25 October 2023

Clarification of Meridian's Response to the Mt Munro Proposed Wind Farm Resource Consent Application Section 92 Additional Information Request

CLIENT	MERIDIAN ENERGY LIMITED
PROJECT	MOUNT MUNRO WIND FARM
TITLE	INDICATIVE FILL DISPOSAL AREAS PLAN
SCALE (A3)	1:15000
DWG No.	1016884.1000-016
REV	3

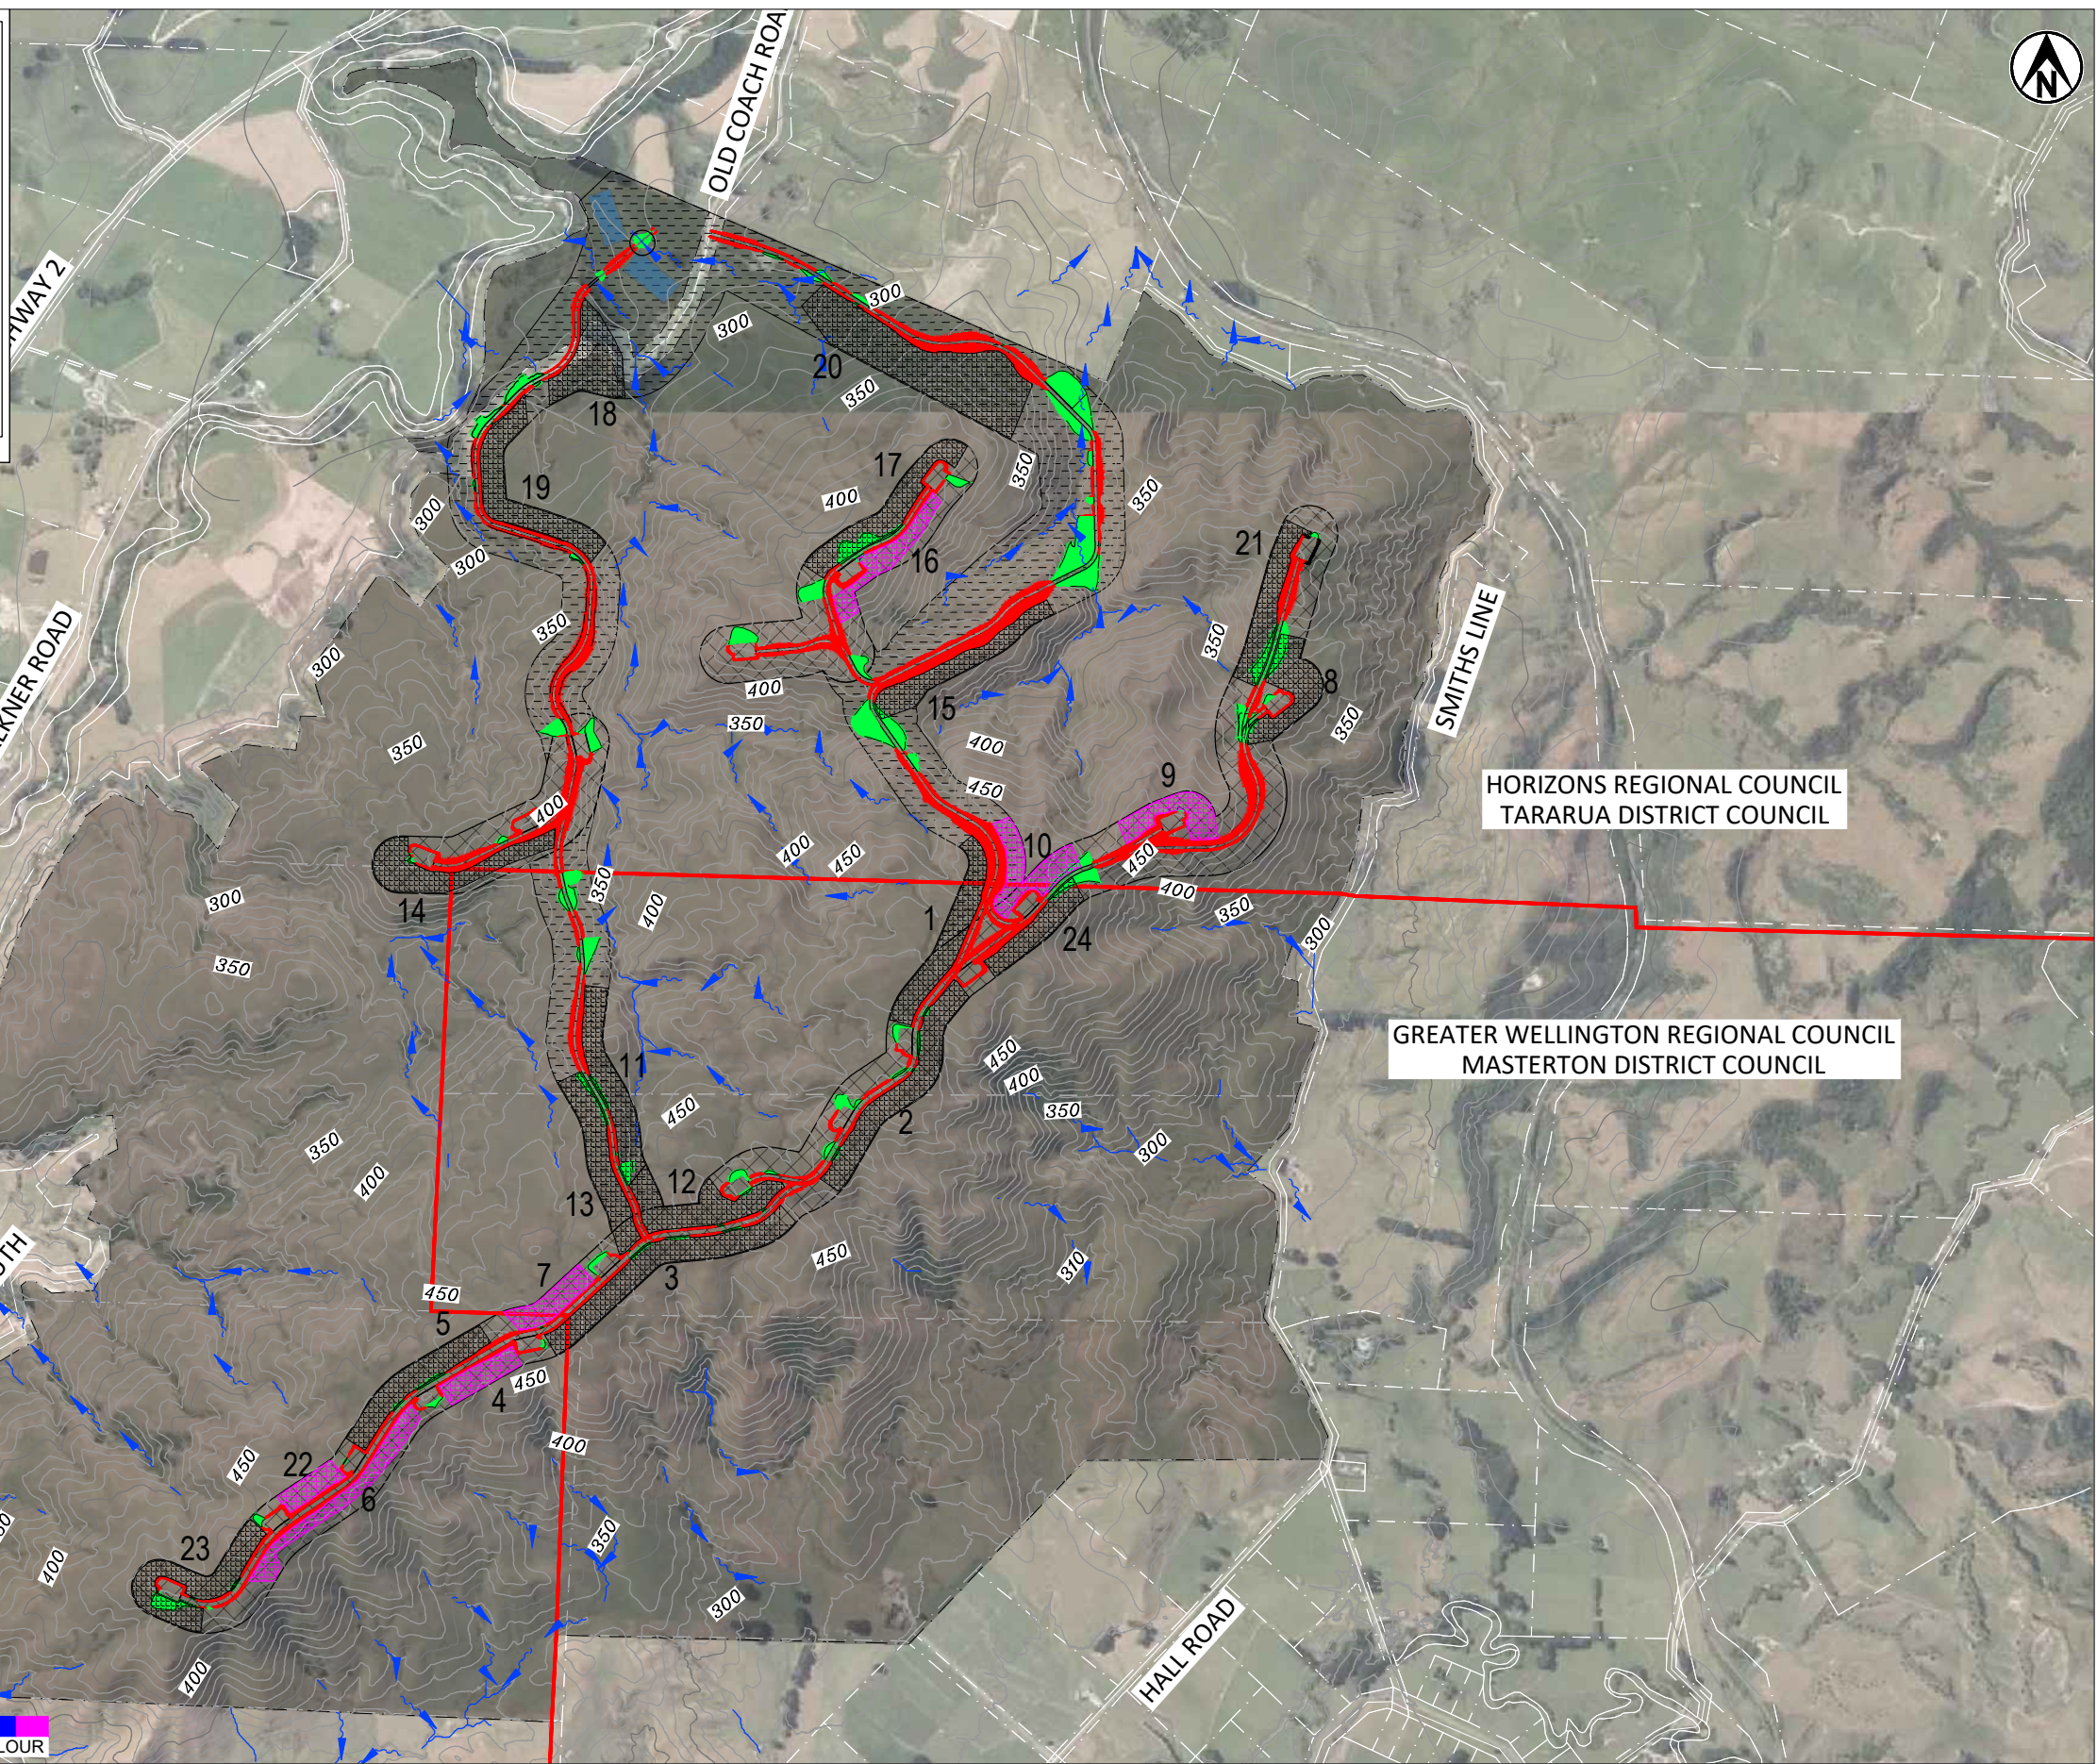
1. *The provision of the Fill Disposal Areas Plan (Drawing 1016884.1000-016) has raised a number of questions from a few of our technical assessors. The calculation of the volume of excess fill requiring disposal may not include all contributions, which may have flow on effects including:*

- a. *Additional excess fill volume would increase one or more of the number/area/volume of excess fill disposal sites within the provided Indicative Fill Disposal Areas plan. This has potential implications for the landscape and visual assessment, to ensure excess fill volume does not result in a series of highly visible, engineered/geometric fill edges/faces, or is significantly higher than anticipated (noting that the s92 response suggests that a significant quantity of fill (approximately 1.2M m³) may be disposed of in relatively visible locations and at up to depths of around 5m). This is critical given the envelope approach being proposed.*

- b. *Adequate representation of the most likely fill disposal areas across the site is also required to inform potential submitters.*
 - c. *Changes to the fill disposal site would require an updated review of the geotechnical effects as well as assessment by other technical disciplines to adequately assess the effects of the works (and may result in other consent requirements being triggered).*

HAIL sites (e.g., by the 'super bin' that contained fertiliser) in the submitted PSI. The PSI says no earthworks will occur, but the submitted Fill Disposal Area Plan & other proposal documents suggest otherwise.

Meridian's consultant civil engineer has revised the earthworks calculations for the proposal, in consultation with Councils technical assessor. As a result of this, the maximum fill disposal volume has increased to approximately 1,410,820m³ (up from 1,217,400m³). The increase is primarily due to a bulking factor being applied to fill disposal volume and an allowance for disposal of cut material from the proposed Old Coach Road works.

Attached as Appendix 1 are two drawings provided by Tonkin + Taylor, confirming the fill disposal areas and a typical cross section of fill. The location and size of the fill disposal areas has increased from what was reported in the original s92 response, due to the bulking factor being applied and a minor allowance for cut material from the Old Coach Road works, and discussions with Councils technical assessor. Meridian's consultant civil engineer has confirmed that the revised maximum fill disposal volume can still be accommodated within these areas.

In terms of visibility, it is understood that the independent landscape architect engaged by Meridian has consulted with the Council's appointed landscape architect, and that there is comfort, noting that the maximum finished gradient of the fill disposal areas is 1(v):3(h). Note, this does not apply to engineered fill required to provide for roads. This fill will have a gradient of 1:2, as shown on the typical cross section in Appendix 1. Given this, a new condition of consent is proffered, for both the district and regional conditions sets (earthworks section), being:

X Earthworks fill areas (aside from the proposed access roads) must be finished with a maximum gradient of 1(vertical):3(horizontal). Engineered fill providing for roads can be finished with a gradient of 1:2.

With this condition, the fill disposal areas can accommodate up to approximately 1,464,850m³ of fill material, exceeding the maximum fill disposal volume of approximately 1,410,820m³.

While the 'super bin' is located within the Turbine Envelope Zone, the earthworks are proposed to be managed within this zone so that this area is avoided. The fill plan included in Appendix 1 has been updated to show no earthworks in the 'super bin' area.

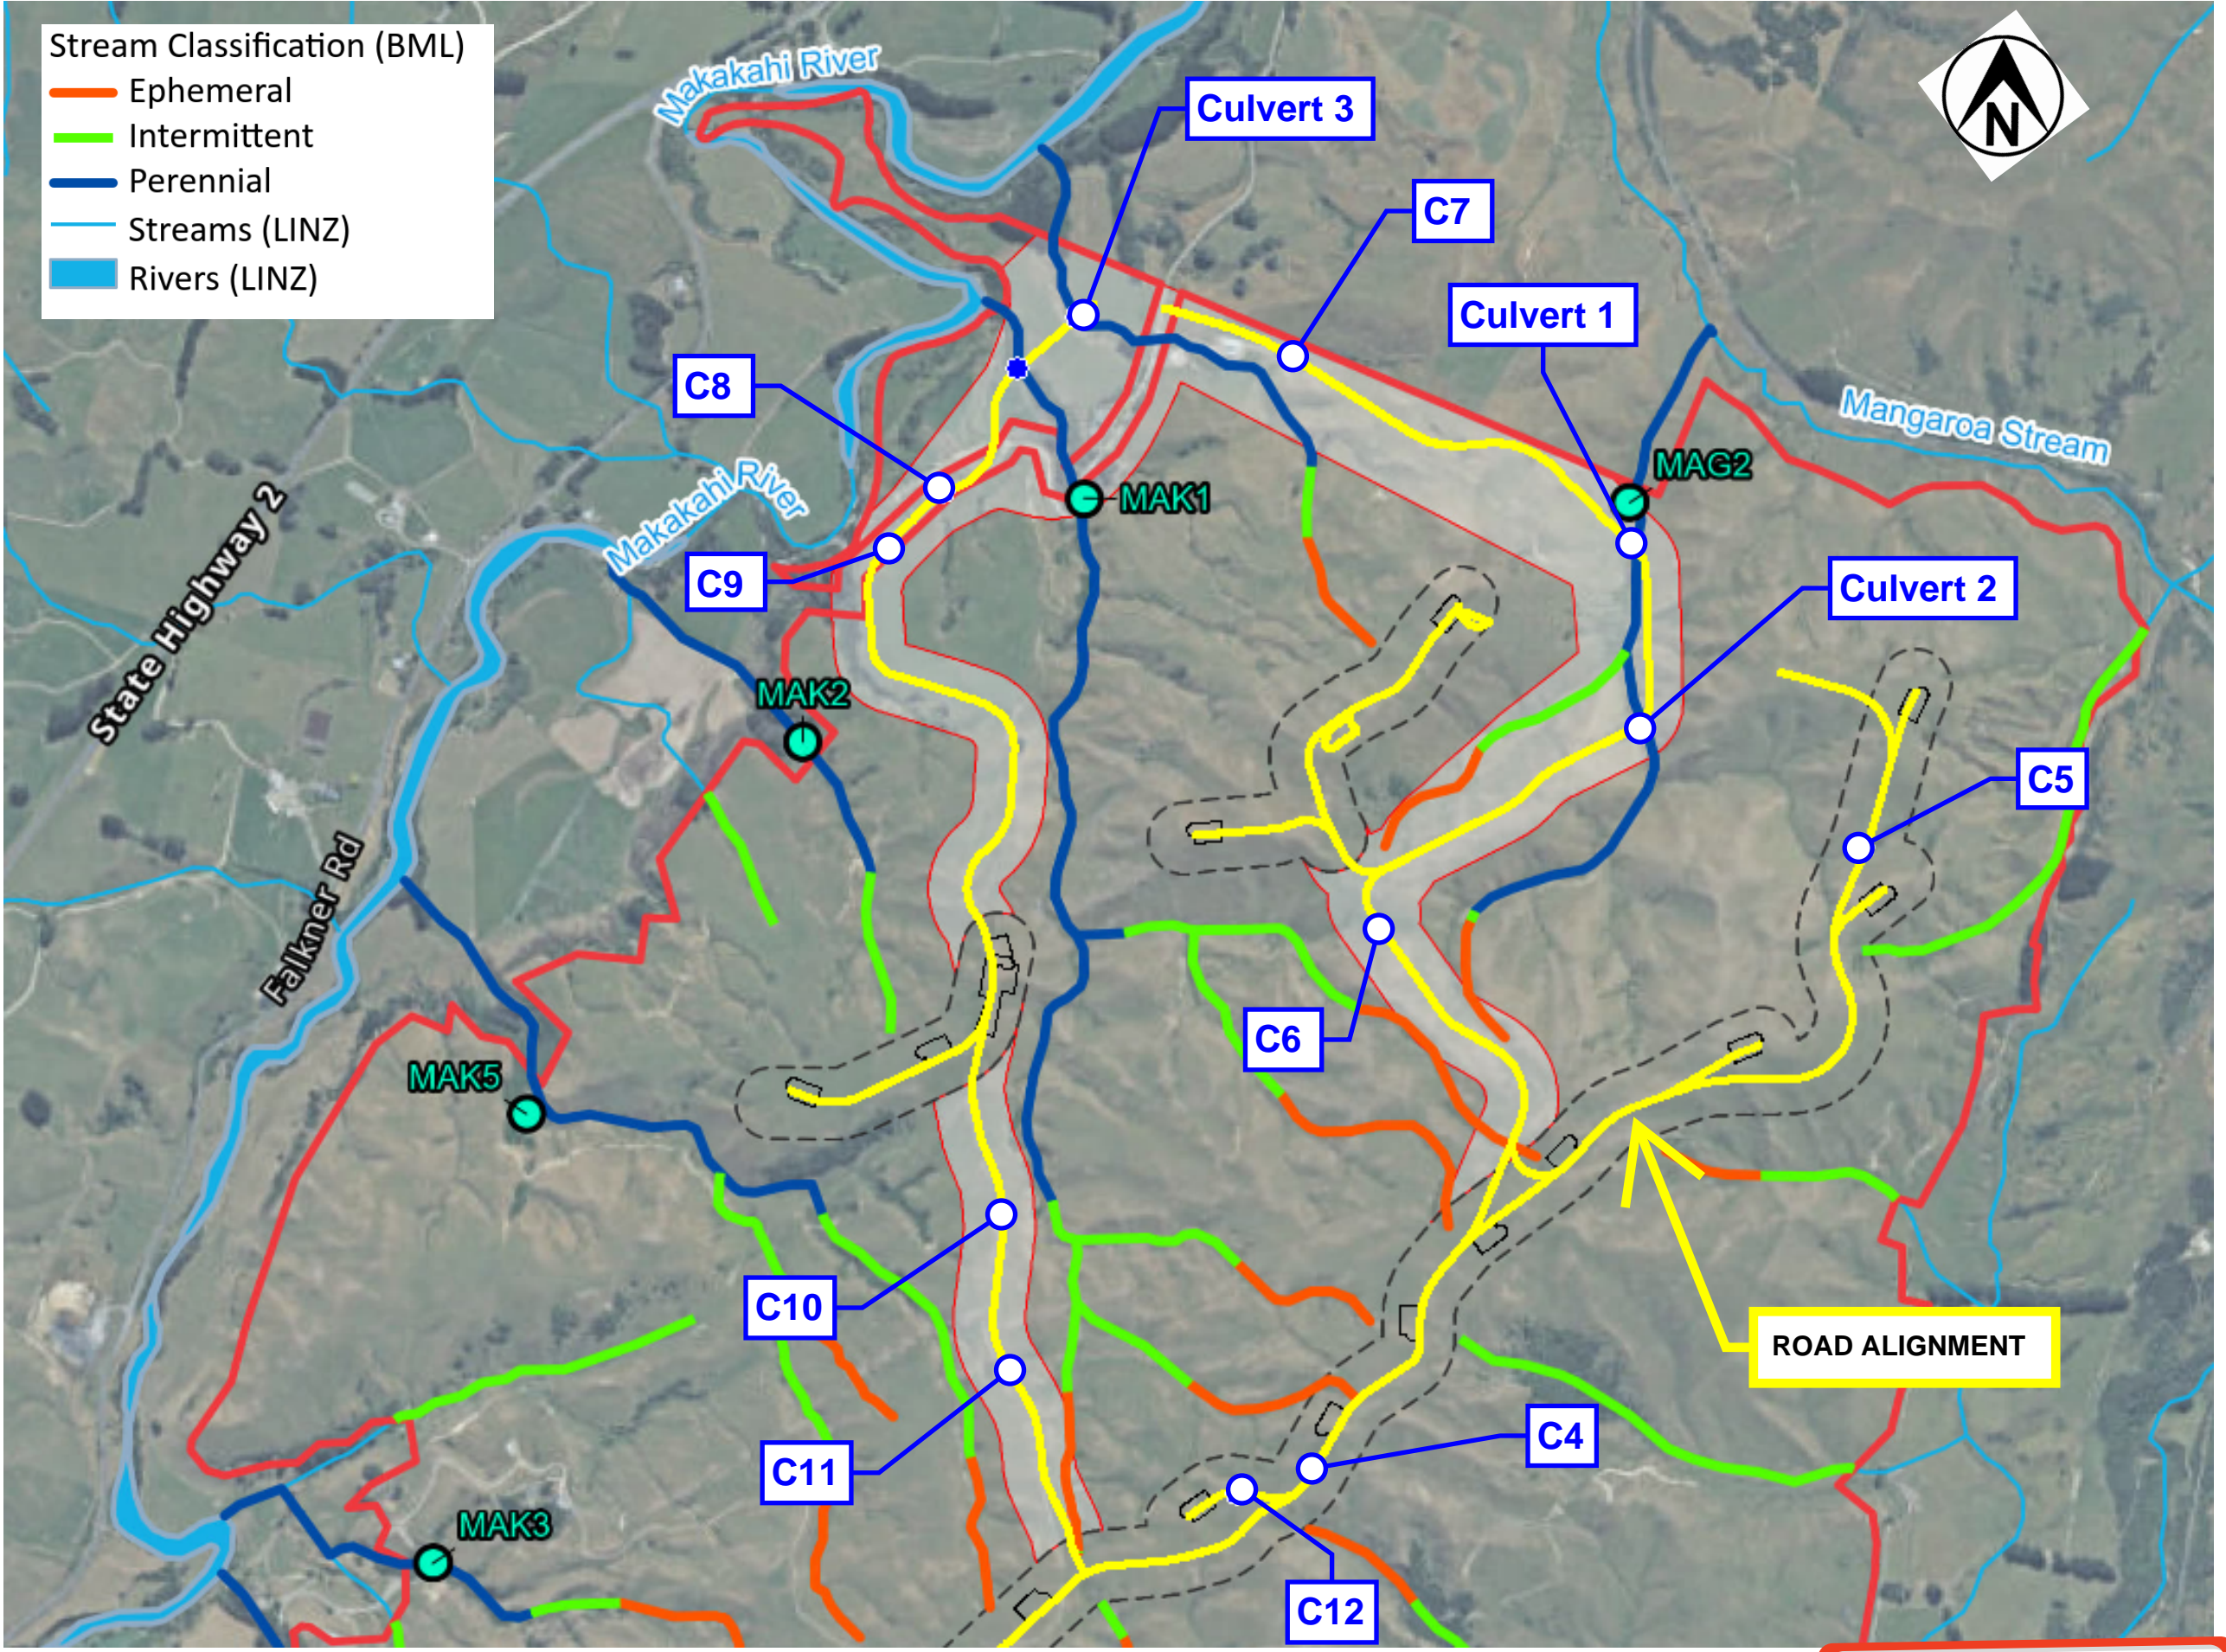
- 3. Given the Fill Disposal Areas take up a large area of the envelope, please confirm how erosion and sediment control measures will be incorporated into the envelope. For example, is there room for SRP's to be used?*

Council has requested *“Given the Fill Disposal Areas take up a large area of the envelope, please confirm how erosion and sediment control measures will be incorporated into the envelope. For example, is there room for SRP’s to be used”*.

The attached technical memorandum from Ridley Dunphy (Appendix 2) confirms that there is sufficient space within the proposed envelopes to incorporate the proposed erosion and sediment control measures.

The location of the potential fill sites has been documented and illustrated within the further information provided by Meridian. I have further assessed the ability to install ESC measures as part of the fill process. This includes the provision of SRPs but also allows for other ESC measures such as super silt fences where applicable.

An important element of the fill volume calculations is that the calculated fill capacity is larger than that anticipated fill volume and in addition to this value engineering through the process will further reduce this fill volume. With these aspects in mind I assess that there is adequate room to establish ESC measures either within the same footprint as the fill or alongside the fill areas within an area of no activity.
